ORIGINATION FORM

Proposed Revisions to a Standard Plans Index
(Please provide all information — Incomplete forms will be returned)

Index Number: 649-020

Index Title: Steel CCTV Pole

STEEL CCTV POLE ASSEMBLY

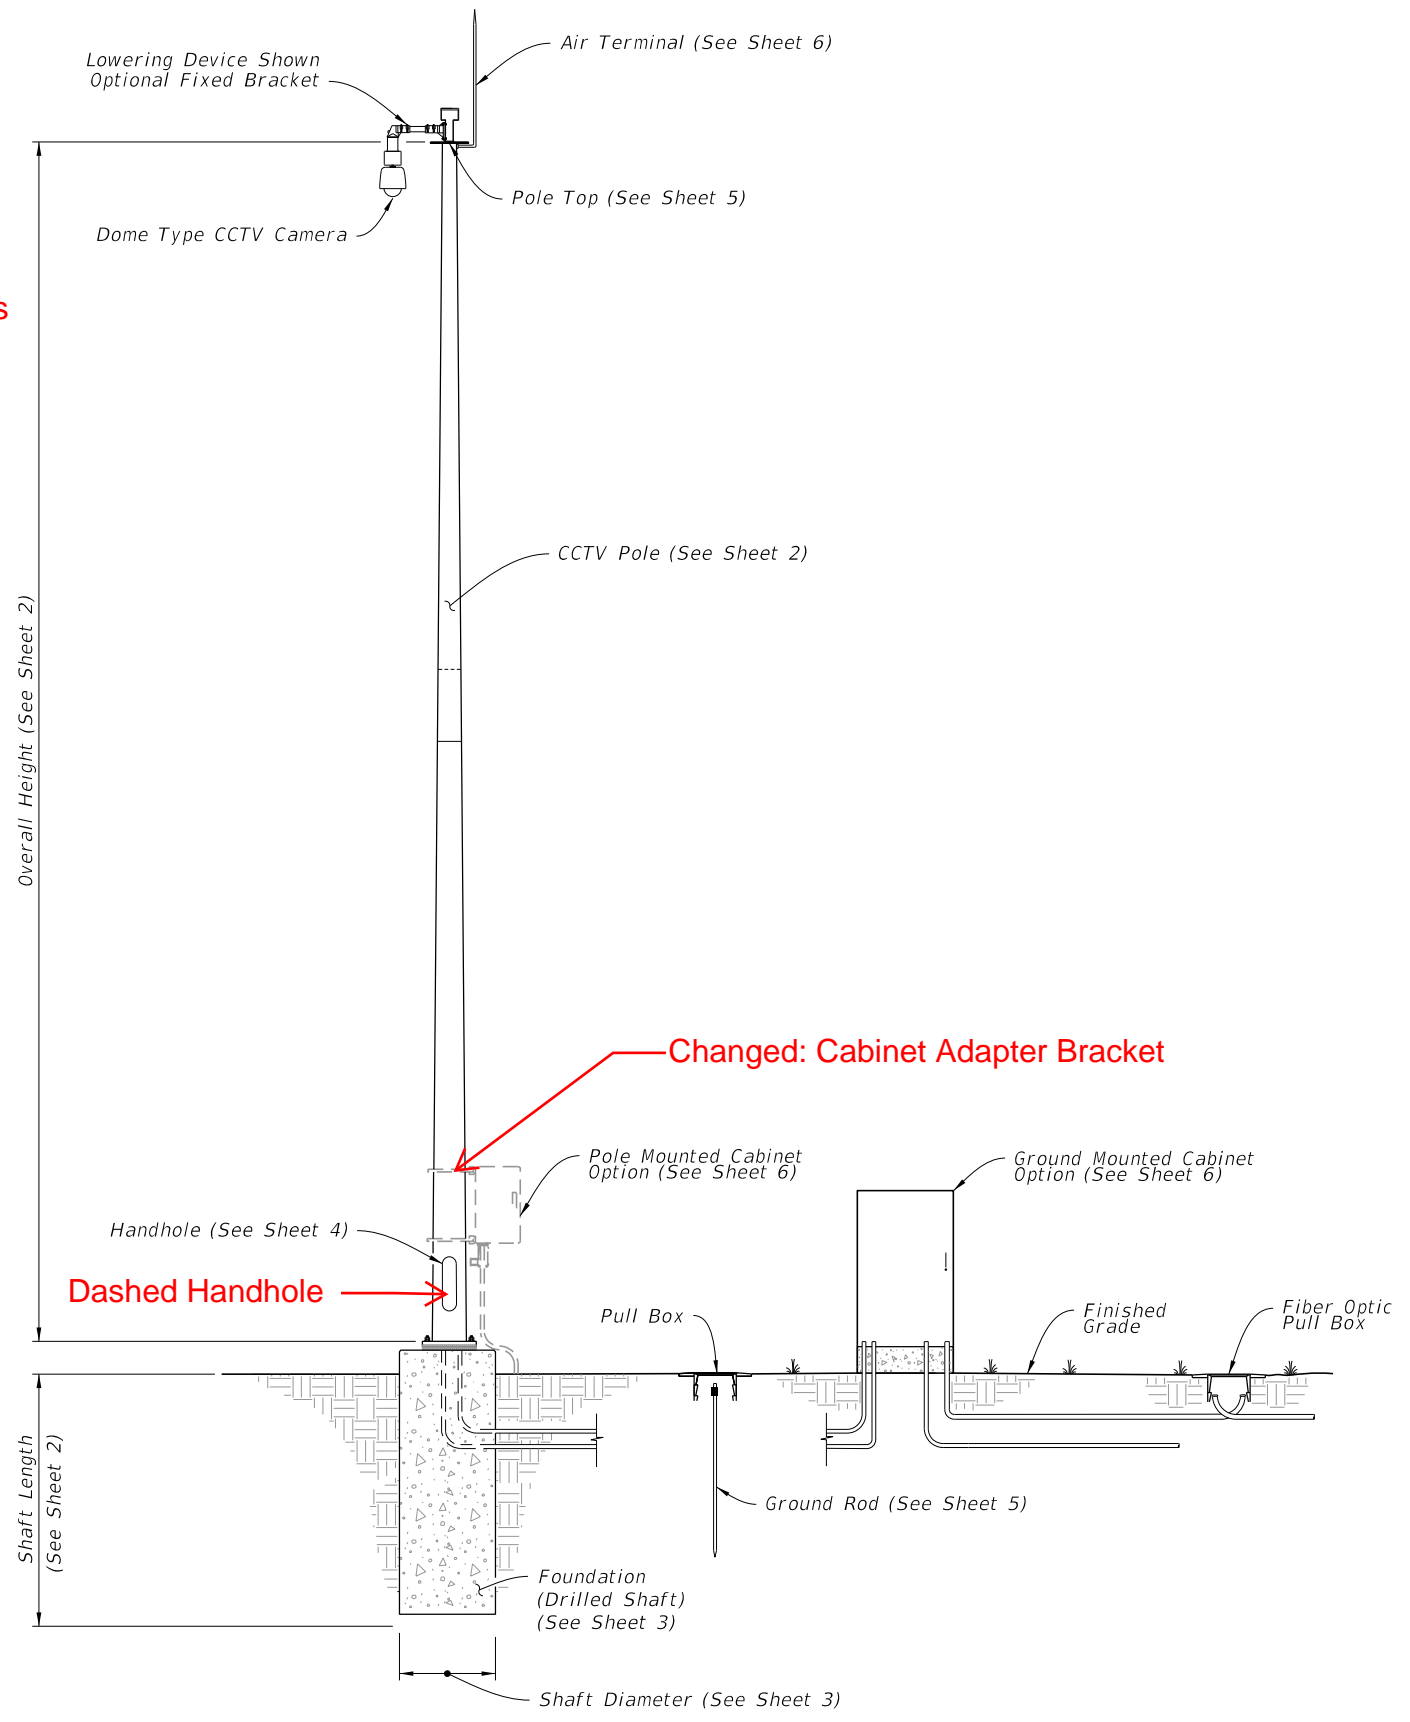
Added New Note 3:
See Index 635-001
for additional details
for Pull Boxes.

Added Note New D:
Install Pole with the
handhole located
away from
approaching traffic.

Added Note E:
Install the Pole
plumb.

Changed: Cabinet Adapter Bracket

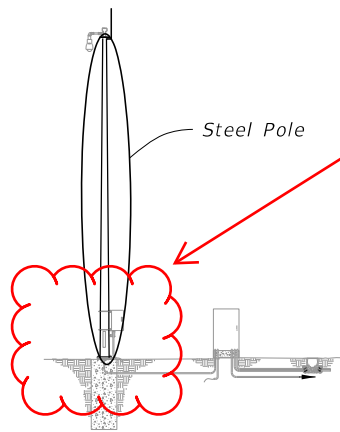
Updated Detail to match Sheet 1

ASSEMBLY

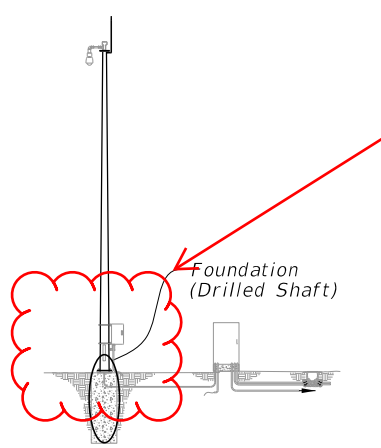
Updated Detail to match Sheet 1

ASSEMBLY

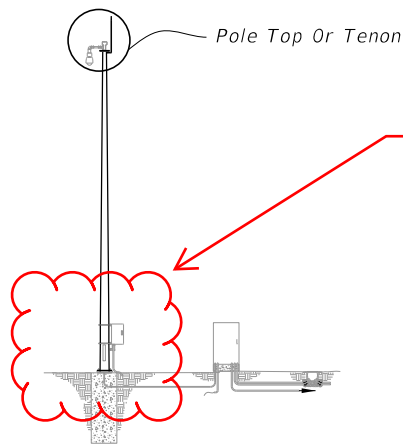
Updated Detail to match Sheet 1

DETAIL "E"

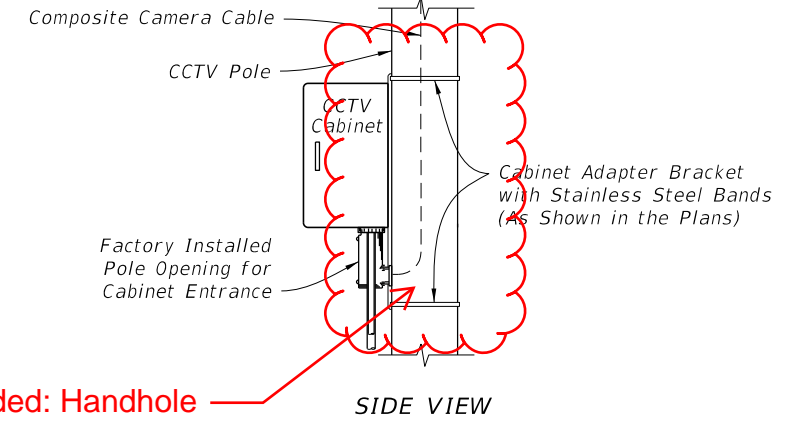
Added: Handhole SIDE VIEW
